STATE OF DELAWARE
EXECUTIVE DEPARTMENT
OFFICE OF
STATE PLANNING COORDINATION

RE: PLUS review – PLUS 2004-12-08 Knollwood Subdivision

Knollwood Subdivision

2004-12-08

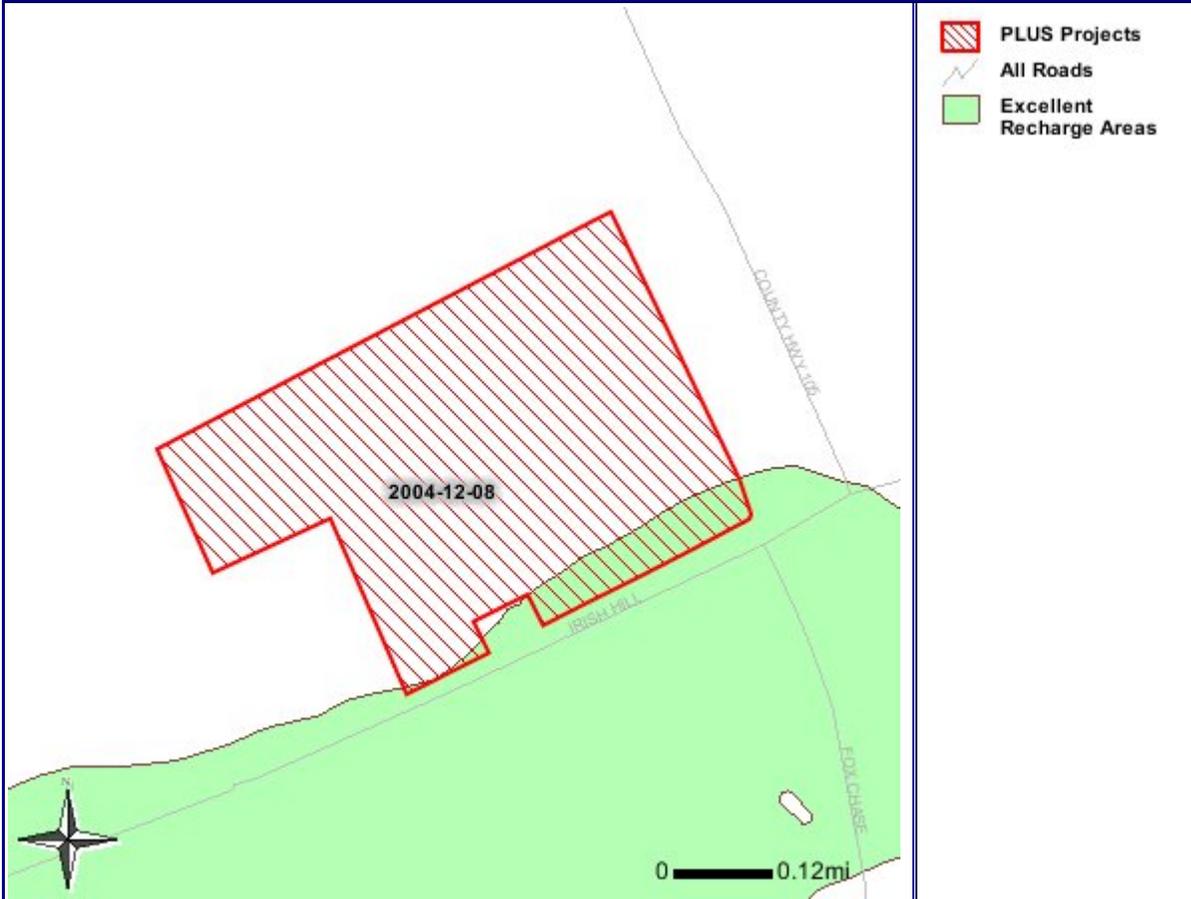
A significant portion of the parcel along Irish Hill Road is located in an excellent recharge area (see map). According to the State law that created the Source Water Protection Program, county and municipal governments will be required to enact ordinances to protect Water Resource Protection Areas. The following language has been excerpted from the draft Source Water Protection Guidance Manual for Local Governments, Supplement 1 - Ground-Water Recharge Design Methodology. While the language is currently draft and the local ordinances are not yet in place, the developer may find the language useful in modifying the site plan to protect the excellent recharge area.

The Department recommends the following (ranked in order of preference):

- a) Preserve WRPAs as open space and parks by acquisition or conservation easement.*
- b) Limit impervious cover of new development to 20 % by right within WRPAs.*
- c) Allow impervious cover of new development to exceed 20% within WRPAs (but no more than 50% impervious) provided the applicant develops recharge facilities that directly infiltrate rooftop runoff.*
- d) Allow impervious cover of new development to exceed 20% within WRPAs (but no more than 50% impervious) provided the applicant*
 - a. develops recharge facilities that infiltrate stormwater runoff from forested and/or grassed surfaces with pretreatment.*
